**TECHNICAL REVIEW OF CLOSURE PLAN
YAKIMA AGRICULTURAL RESEARCH LABORATORY
YAKIMA, WASHINGTON**

DRAFT REPORT

**U.S. ENVIRONMENTAL PROTECTION AGENCY
Office of Waste Programs Enforcement
Washington, D.C. 20460**

Work Assignment No.	:	567
EPA Region	:	10
Site No.	:	None (R)
Date Prepared	:	October 3, 1986
Contract No.	:	68-01-7037
PRC No.	:	15-5675-23
Prepared By	:	PRC Environmental Management, Inc.
Telephone No.	:	312/938-0300
EPA Primary Contact	:	Andy Boyd
Telephone No.	:	206/442-8582

Figure 1

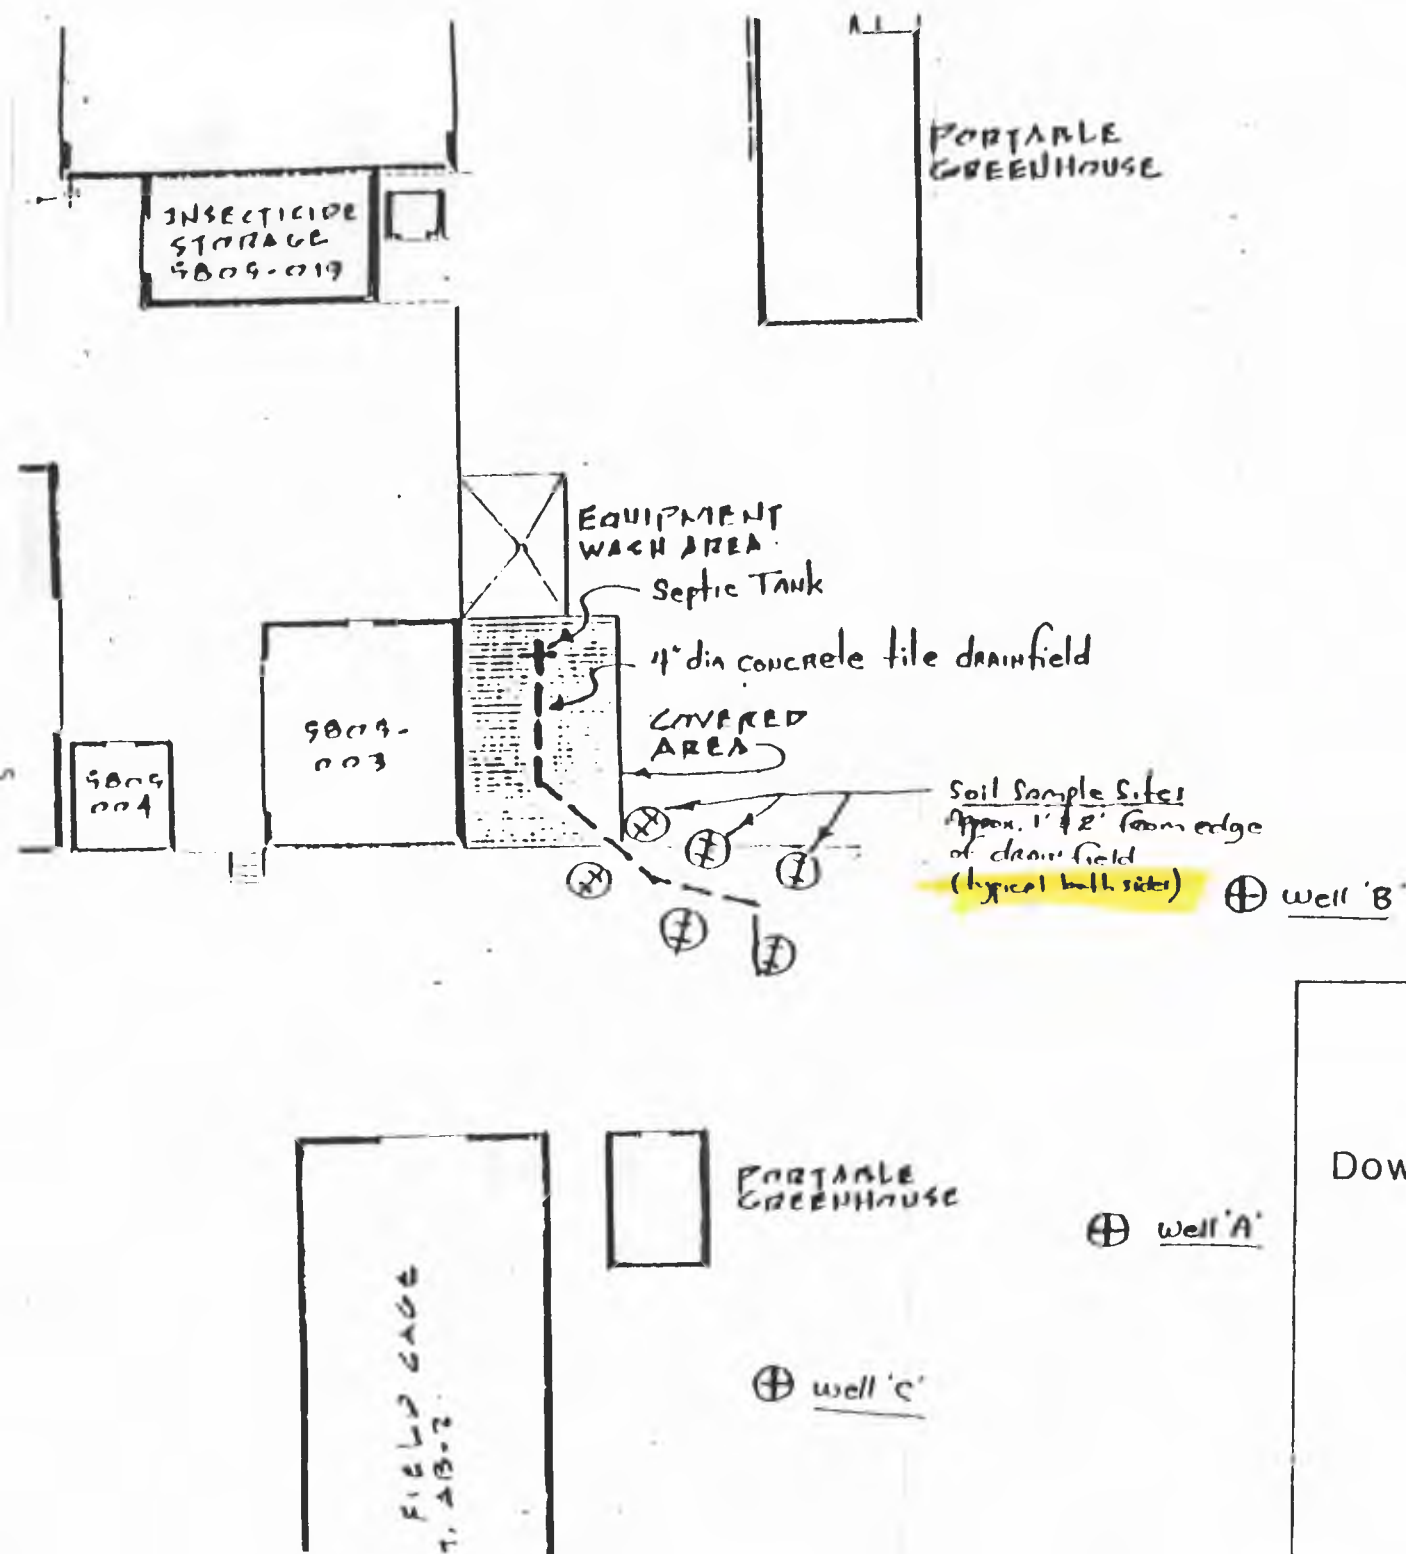
IS this the total depth

- o YARL proposes to place downgradient monitoring wells at a distance of 50 feet from the drainfield. Ground water at the YARL site exists at a relatively shallow depth, and the soil horizon information does not indicate potentially significant lateral movement of contaminants. At such sites, ground-water monitoring wells should be placed as close as possible to the waste management unit to facilitate immediate detection of contamination in the uppermost aquifer.
